UNITED STATES PATENT AND TRADEMARK OFFICE

APPLICATION NO.	FILING DATE	FIRST NAMED INVENTOR	ATTORNEY DOCKET NO.	CONFIRMATION NO.
10/664,371	09/17/2003	Jorge L. Orbay	HAN-022	4572
36822 7590 07/02/2008 GORDON & JACOBSON, P.C. 60 LONG RIDGE ROAD SUITE 407 STAMFORD, CT 06902				
EXAMINER RAMANA, ANURADHA				
ART UNIT		PAPER NUMBER		
3733				
MAIL DATE		DELIVERY MODE		
07/02/2008		PAPER

Office Action Summary**Application No.**

DETAILED ACTION

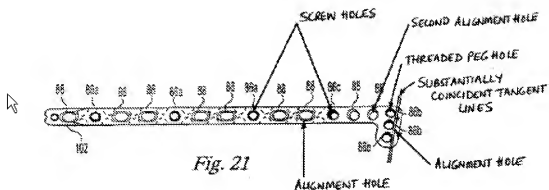
Weaver et al. disclose a bone fixation plate 80 including: a head angled relative to a the shaft; the head portion defining a first set of threaded holes 86b; alignment holes much smaller in diameter than the threaded holes for provisional fixation of the bone plate; a second alignment hole 88; and a plurality of screw holes 86a in the shaft of the bone plate (Figs. 20-26, col. 6, lines 58-67 and col. 7, lines 1-17). See marked up Fig. 21 from Weaver et al. on the following page.

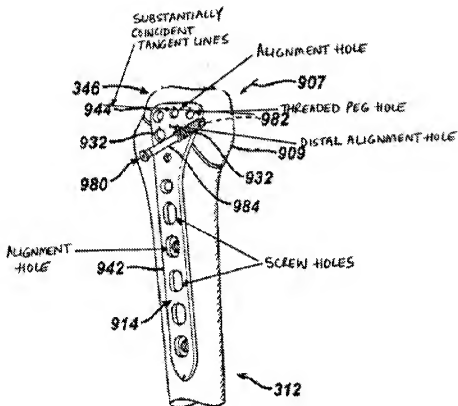
Wack et al. disclose a plate 914 defining a first set of peg holes structurally adapted to engage a threaded head of a fixation peg and at least one non-threaded alignment hole 871 having a second relatively small diameter wherein the first alignment hole defines a tangent line substantially coincident with a line tangent to the first set of threaded (Figs. 20-22 and paras [0118]-[0162]). See a portion of Fig. 20 marked up to show features of Applicant's invention below.
